UNITED STATES PATENT AND TRADEMARK OFFICE

APPLICATION NO.	FILING DATE	FIRST NAMED INVENTOR	ATTORNEY DOCKET NO.	CONFIRMATION NO.
09/476,521	01/03/2000	Herbert Gropp	RUM212	7964

Office Action Summary

EXHIBIT
X

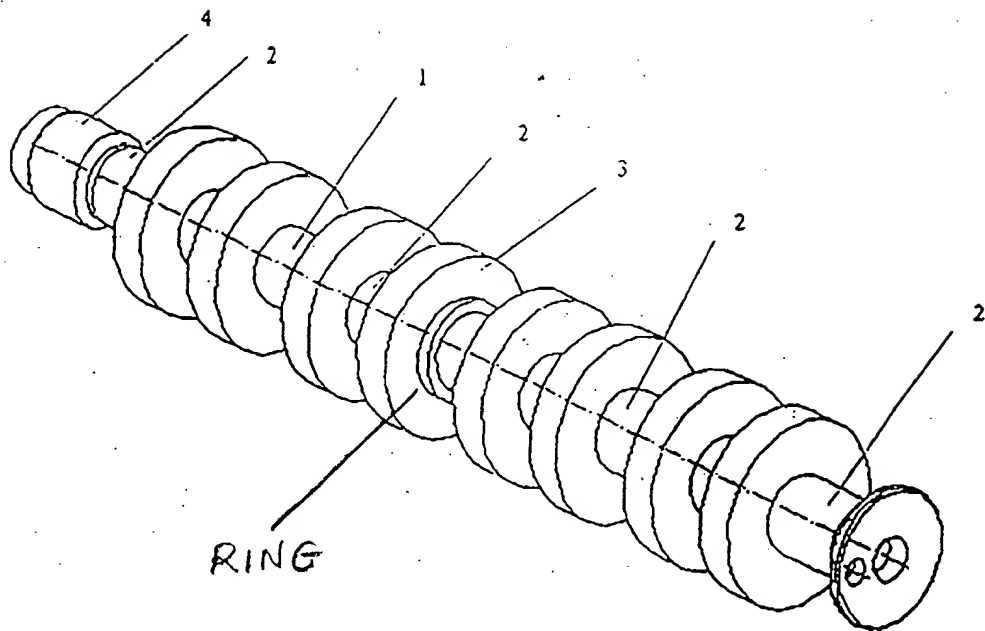
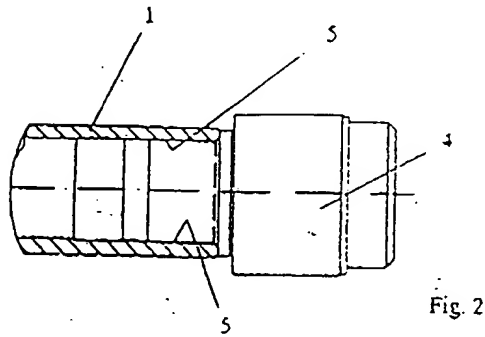
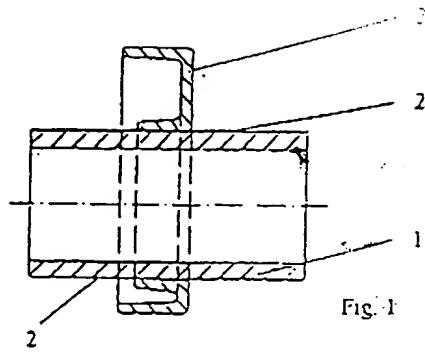
- (b) new Fig. 3 introduces new matter, such as, the deletion of a ring (unnumbered, see Exhibit attached). The original Fig. 3 shows the ring located adjacent to the cam 3, however, new Fig. 3 now does not show such ring. See *Twin Disc v. United States*, 231 USPQ 417, 435 (US Cls. Ct. 1986)(new matter by deletion).
